Eaton's Cooper Lighting Business Comments on Staff Workshop on Proposed Lighting Efficiency Measure for Residential and Nonresidential Buildings

California Title 24 2016 Proposals – Attachment A

JA8 – Use of E26 base LED lamps in recessed downlights

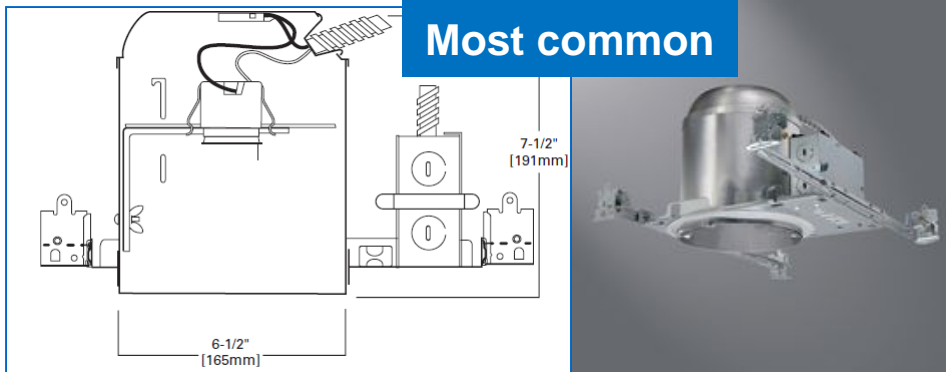
LED lamps used in ICAT recessed downlights having E26 sockets will result in misuse of the technology creating unreliable results and unsafe conditions

Based upon actual test data from 2013 through 2014 in 6” can (worse for smaller cans!)

- Greater than 13W, can potentially exceed LED lamp manufacturer’s warranty thermal limits in enclosed downlight
- Greater than 23W, can potentially exceed UL 120C limits for plastic when used in enclosed downlight
- Greater than 26W, can potentially exceed UL 120C limits plastic when used in open downlight

Code should not encourage product misuse resulting in poor performance and exceeding UL conditions of acceptability

Comparison of ICAT recessed housings

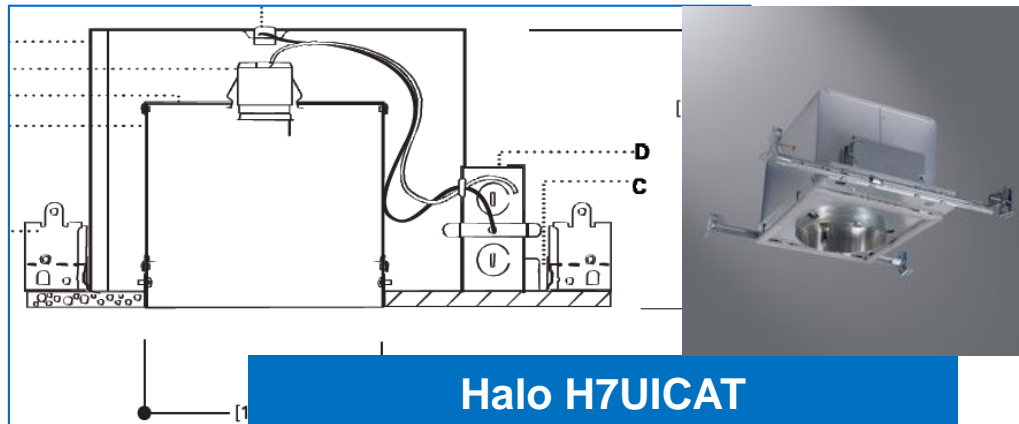
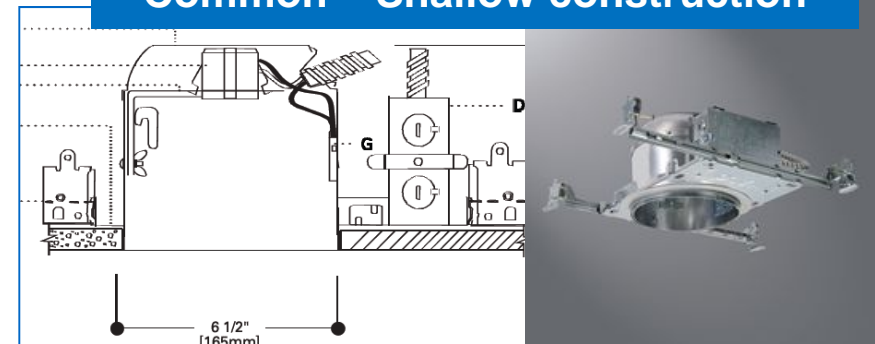
- LED Lamp test specs do not cover “reality” of what is installed
- LED Lamp specifications not written to address recessed downlighting safety requirements
